CITY OF ALBUQUERQUE

Re: FIRE STATION # 21
11401 Coors Bypass NW
Approval of Permanent Certificate of Occupancy (C.O.)
Engineer's Stamp dated 02/12/2004 (A-13/D13A)
Certification dated 11/14/2005

DRAINAGE CERTIFICATION

CITY OF ALBUQUERQUE PUBLIC WORKS DEPARTMENT ENGINEERING DEVELOPMENT GROUP				
TITLE: GRADING PLAN				
Design Review Committee	City Engineer Approval	Last Design Update	MO/YR/YR	MO/YR/YR
City Project No. 1000593	Zone Map No. A-13	Sheet # C1.1	Of ##

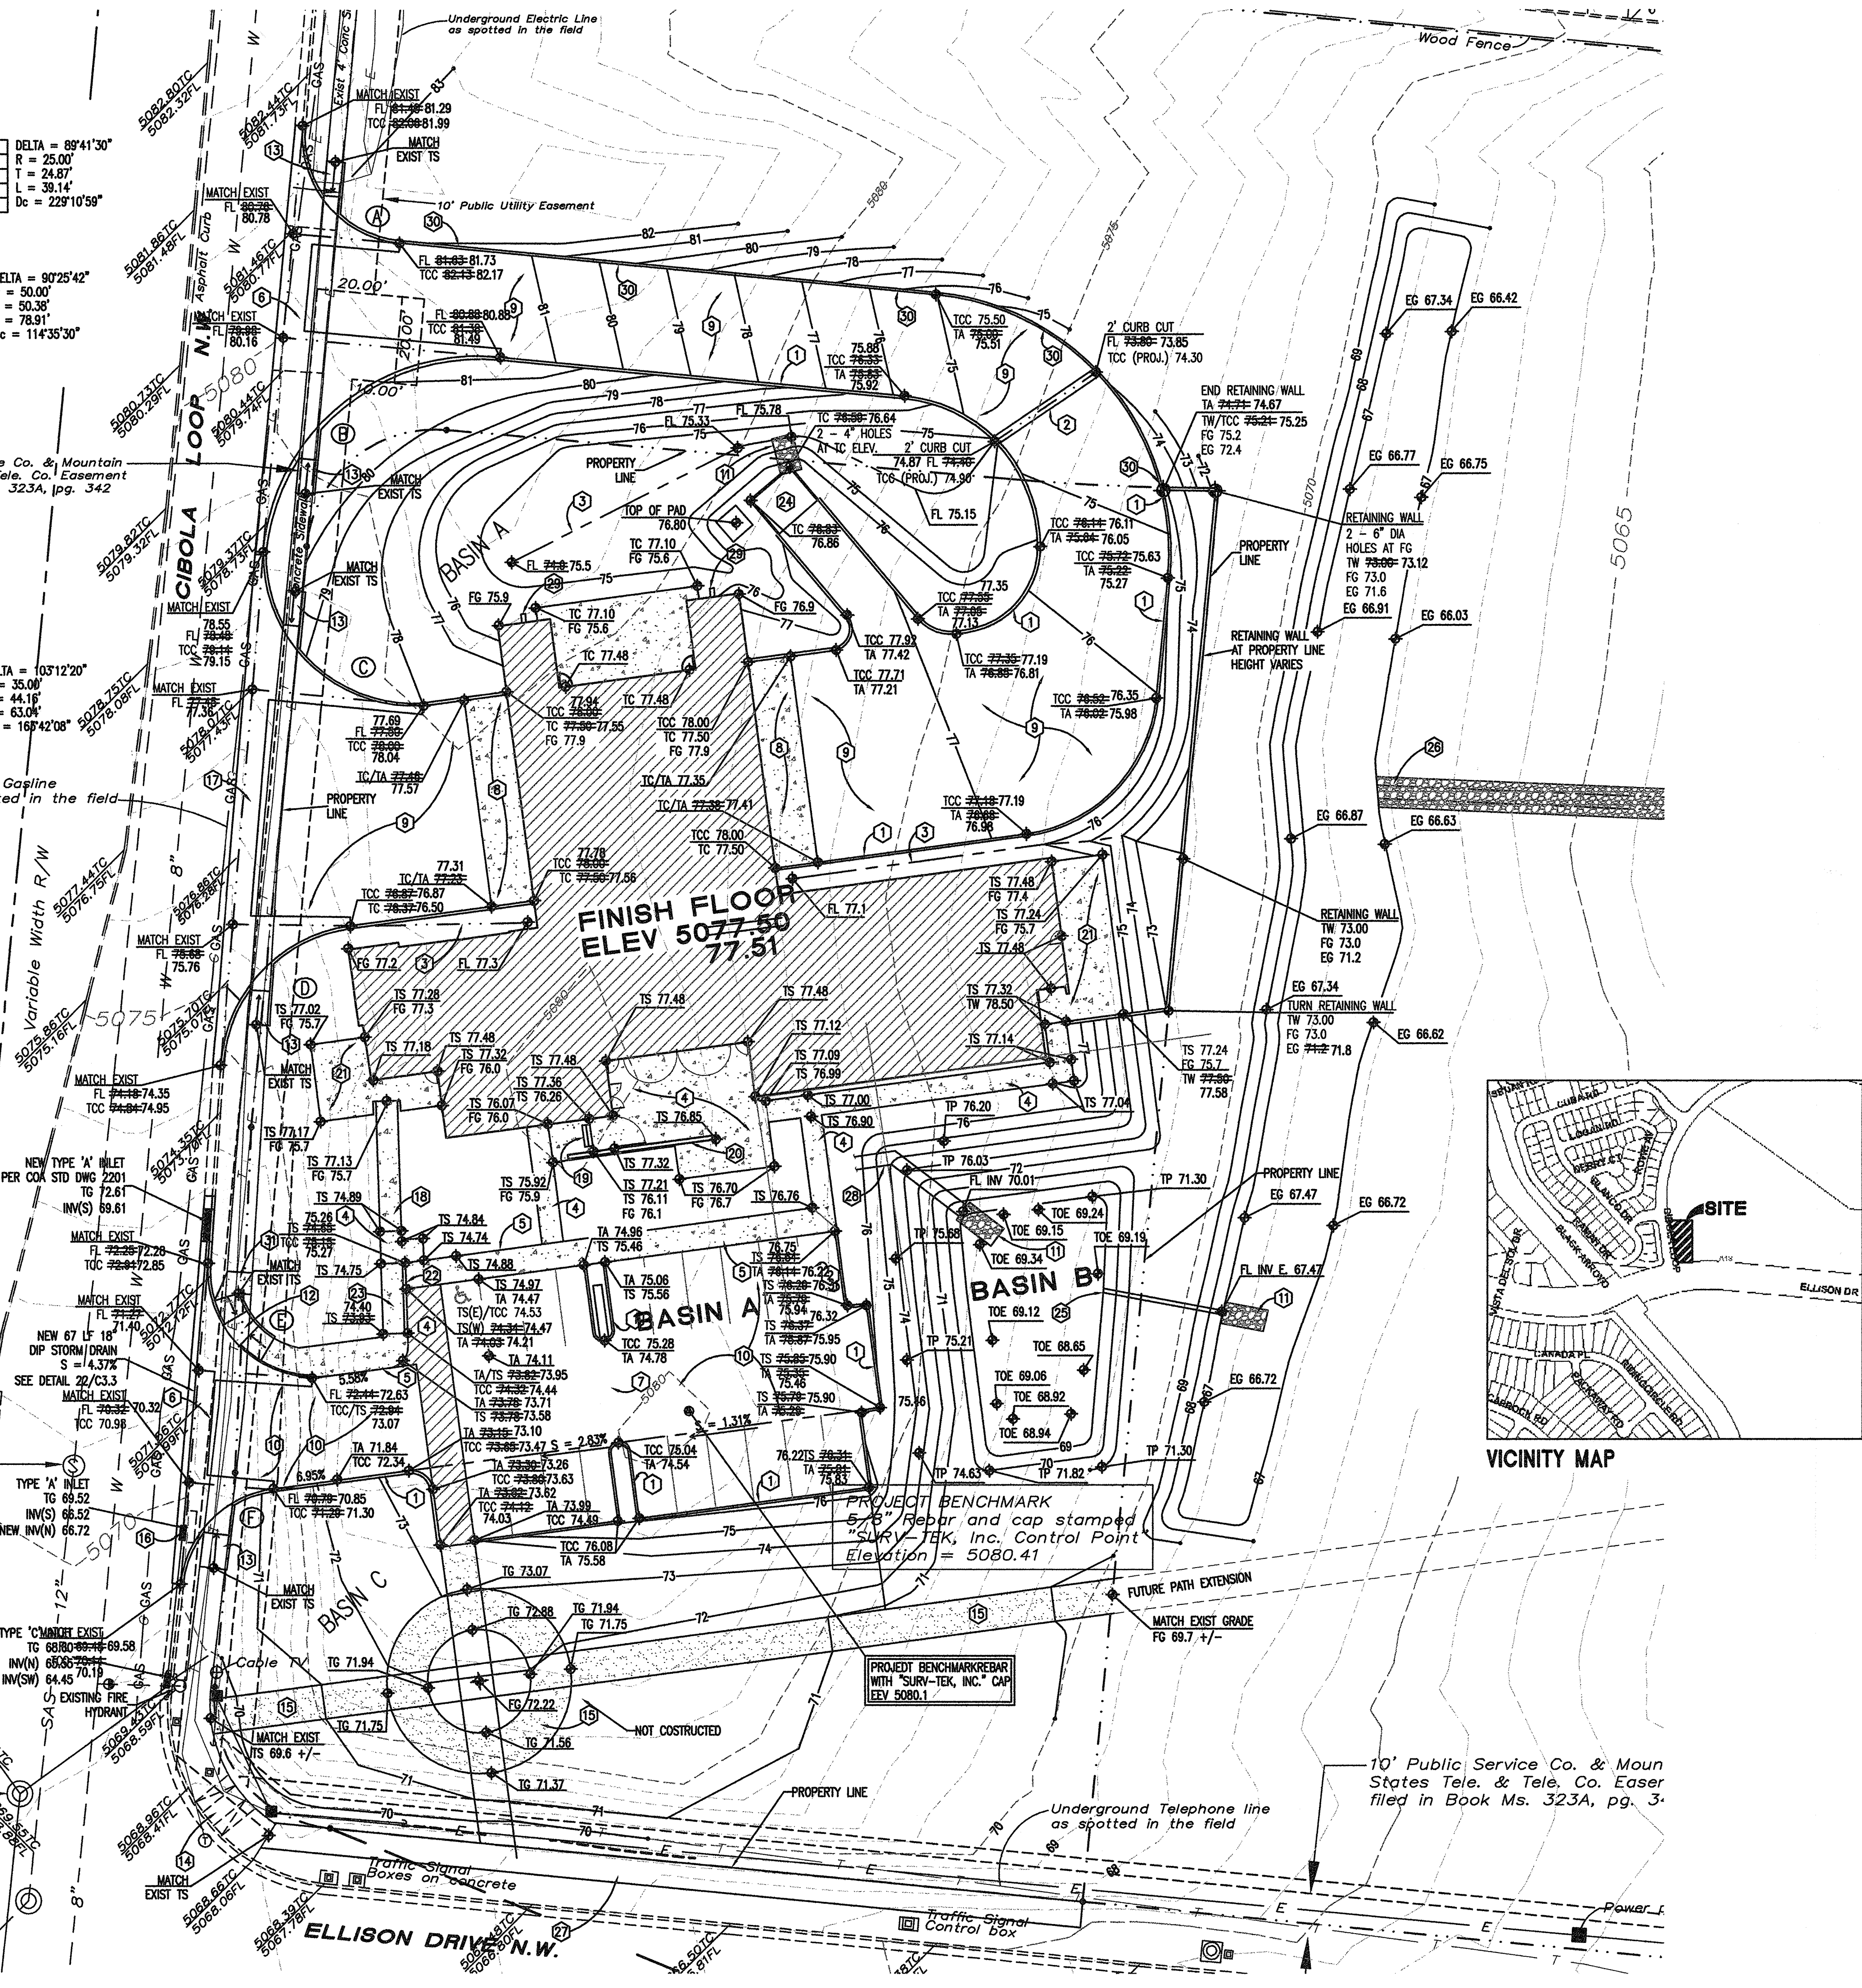
Based upon the information provided in your submittal received 01/10/2006, the above referenced certification is approved for release of Permanent Certificate of Occupancy by Hydrology.
